September 4, 2014

**Subject: Convenience Store and Fuel Station Development – 2282 Congress Street**  
**Applicant: Portland Property Holdings, LLC**  
**Response to Ben Viola’s Review Comments Dated August 22, 2014**

DRAWN: CMW  
DESIGNED: SRB  
CHECKED: SRB  
FILE NAME: 3118-SP  
DATE: OCTOBER 2013  
SCALE: AS NOTED  
JOB NO.: 3118  
SHEET **C-9.0**

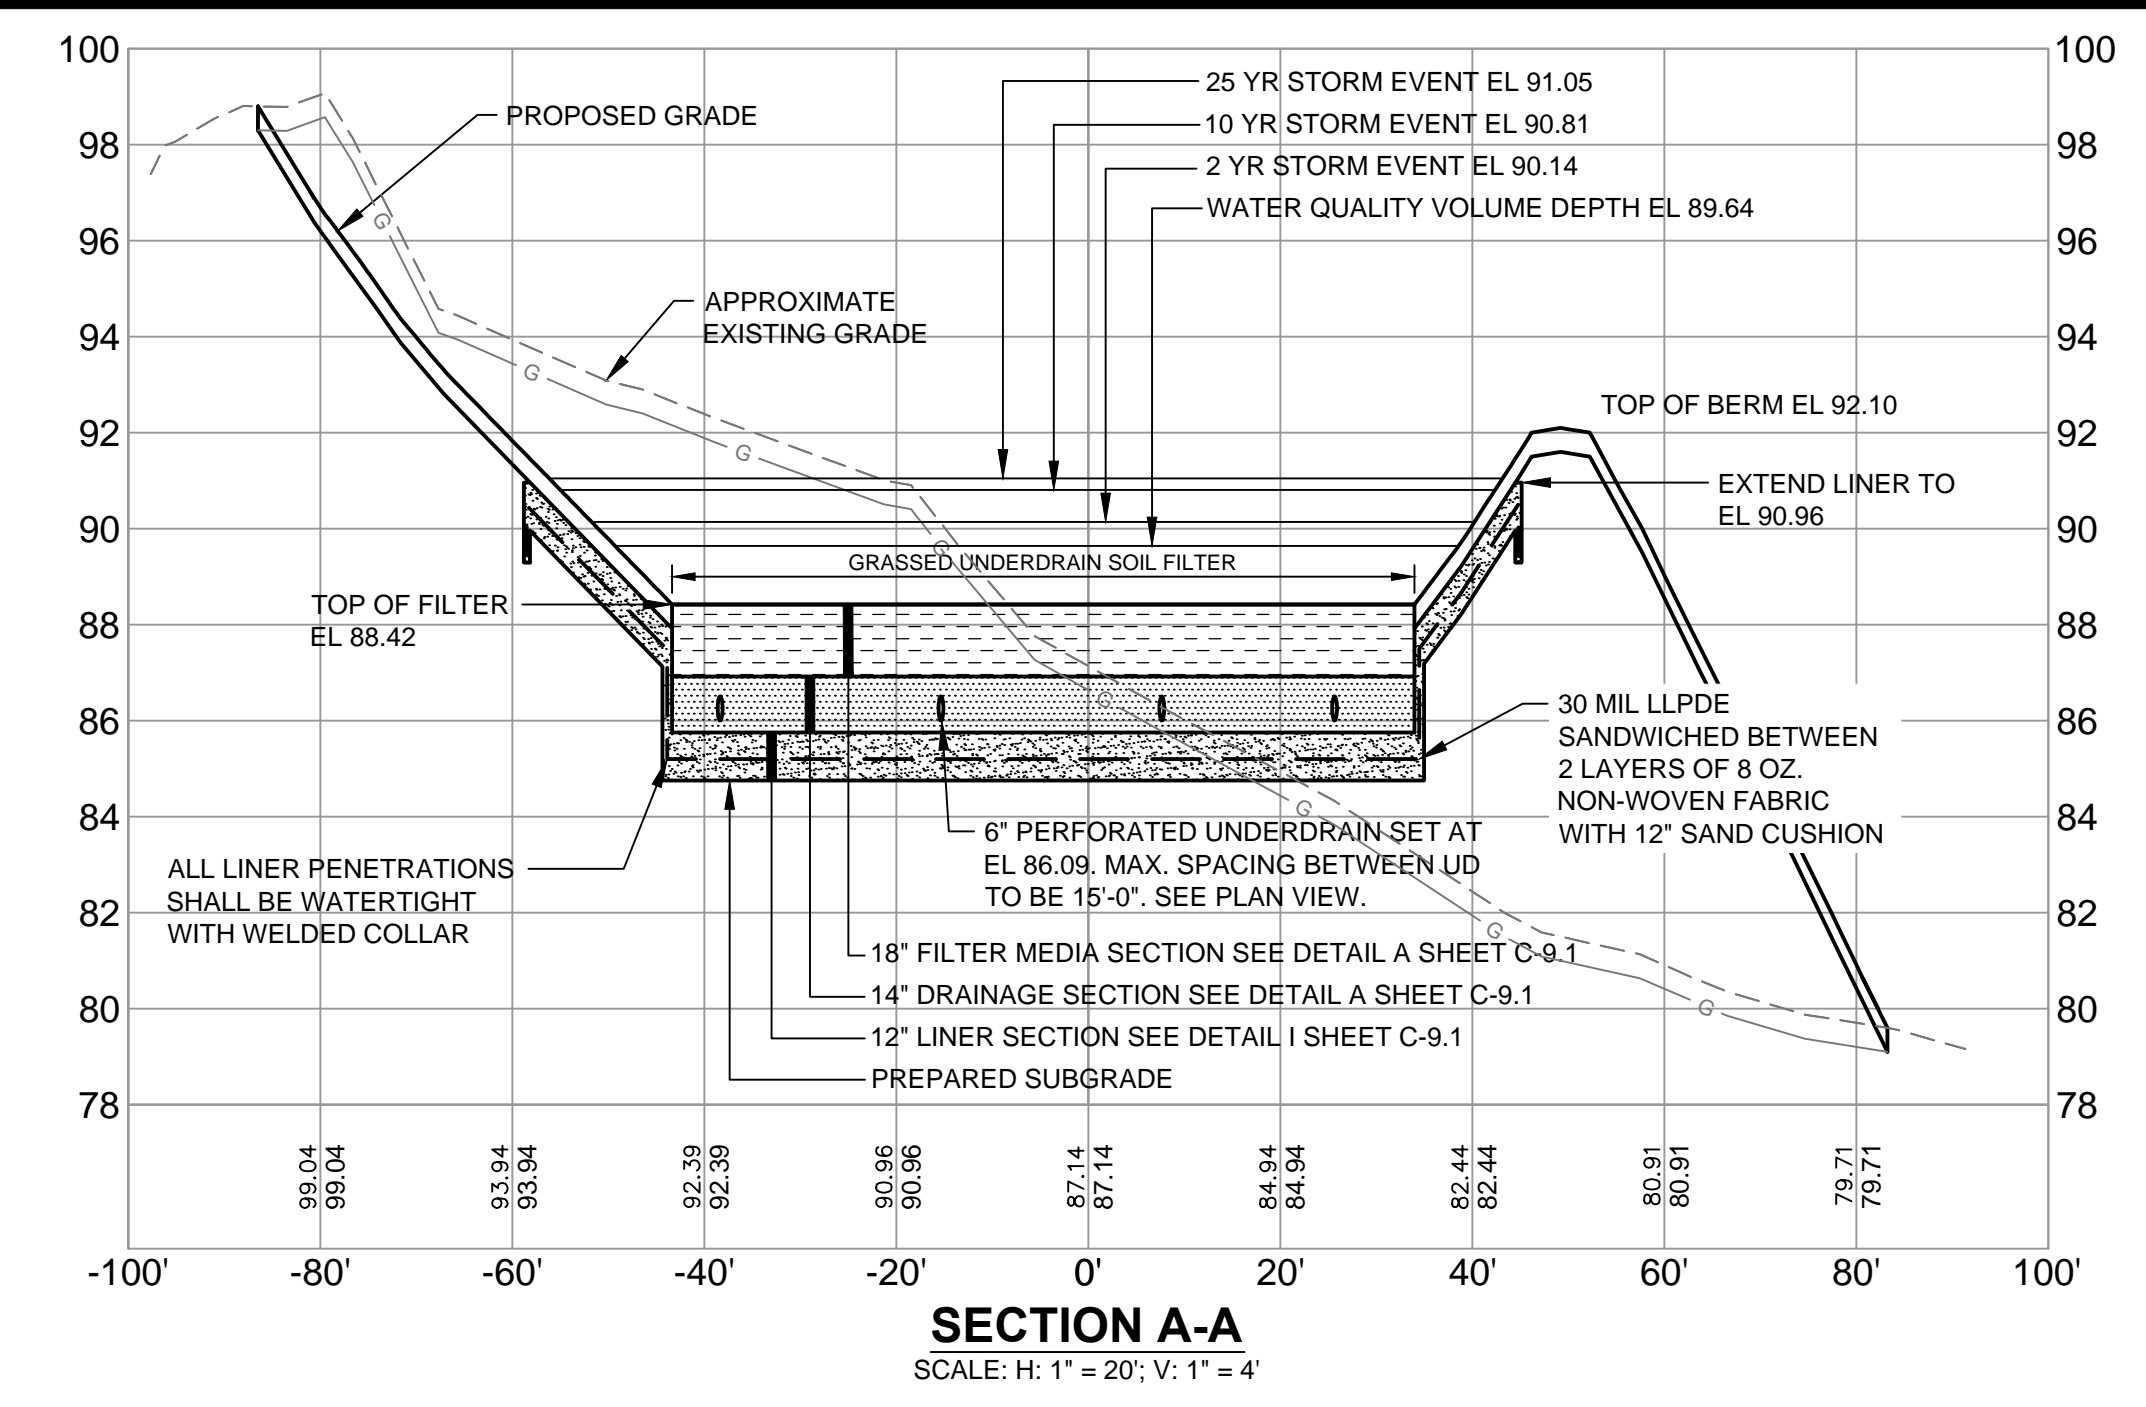
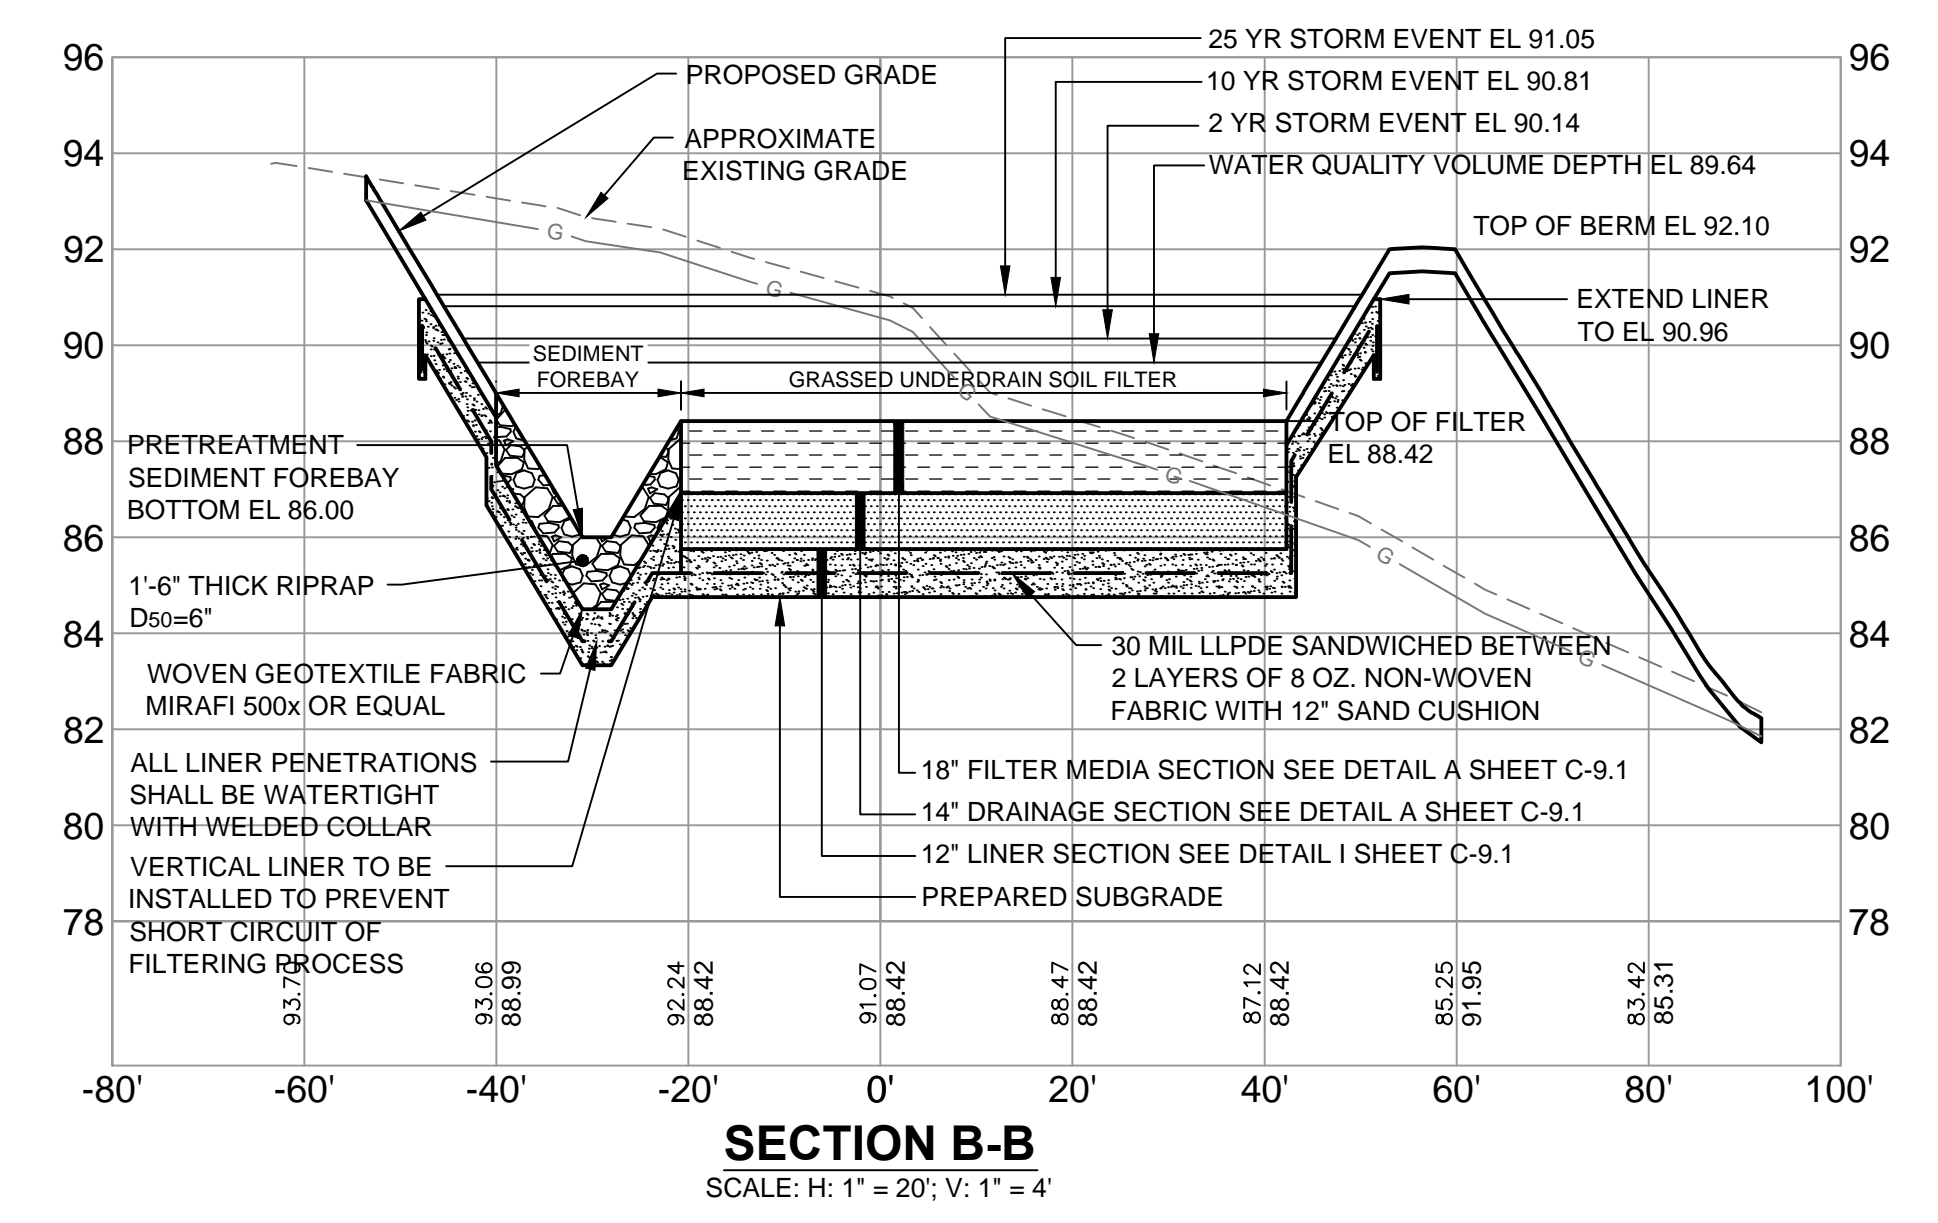
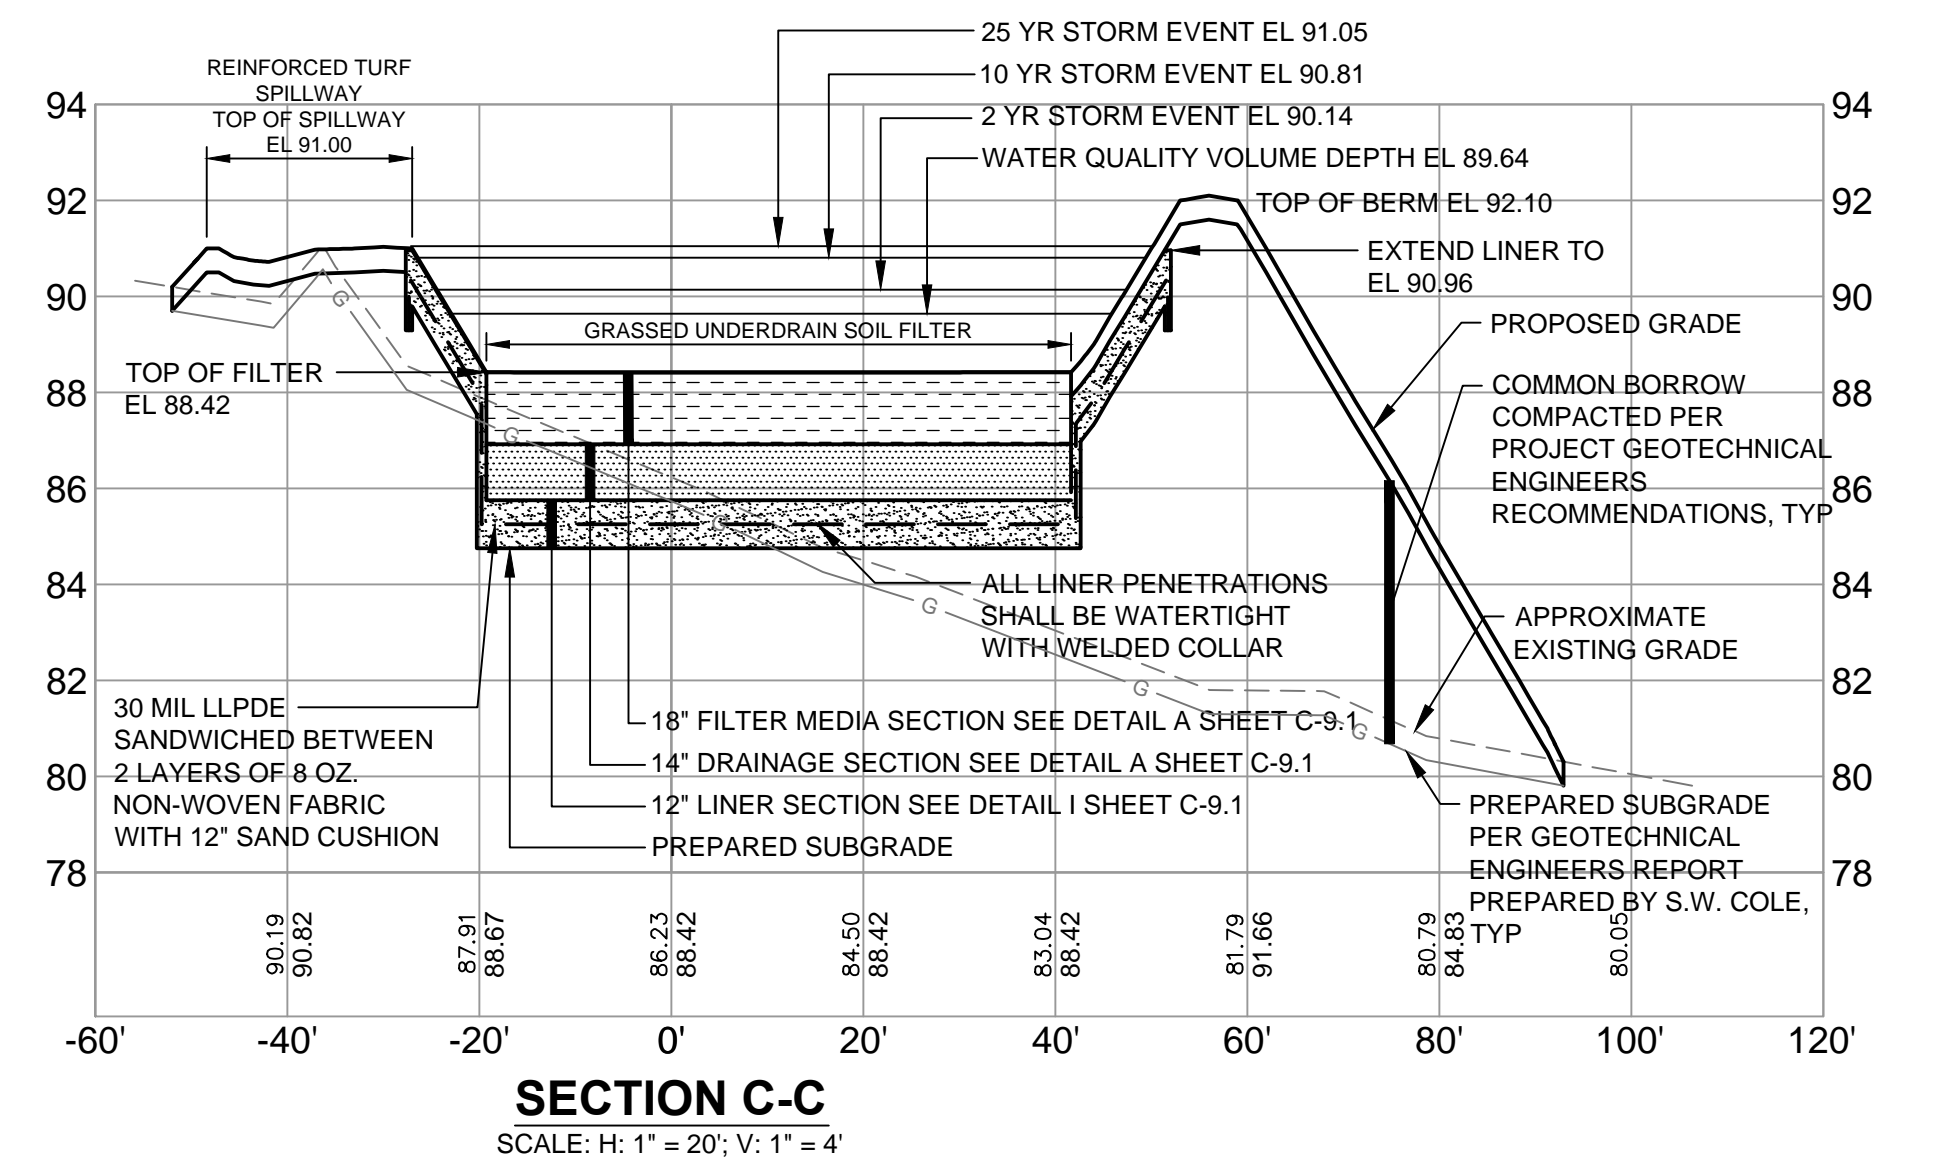
*Construction oversight notes need to be added to the plans. I have attached the Construction Oversight Notes for the applicant to pick which one apply to this project. Notes such as the ones for the underdrained soil filter needs to appear next to the detail for the underdrained soil filter.*

Sheets C-3.0, C-9.0 and C-9.1 have been adjusted to reflect the physical changes to the stormwater system as well as the pond stage elevation changes.

The construction oversight notes for the grassed underdrained soil filter have been added to Sheet C-9.0. The revised sheet C-9.0 is enclosed with this letter.
